## Service Bulletin SB.JS-006

Inspection of sliding bush on the landing gear handle

Service Bulletin Landing Gear Bush Handle

Figure 1: Landing gear handle with unseated brass bush

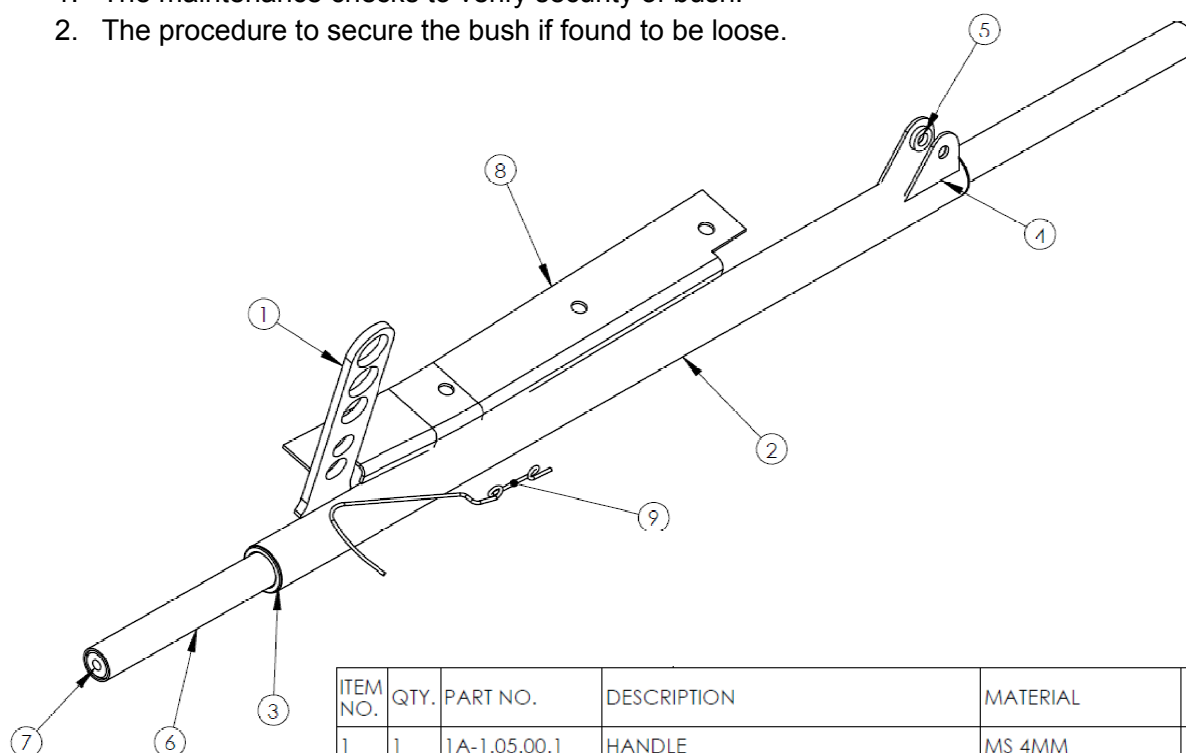
It was reported by a customer that the landing gear could not be fully extended and locked down after retraction. This may lead to the collapse of the main landing gear during landing. Investigations showed that the front sliding brass bush bonded to the landing gear arm unseated and slid out during retraction. During the subsequent extension of the landing gear the bush prevented the landing gear arm from moving all the way forward.
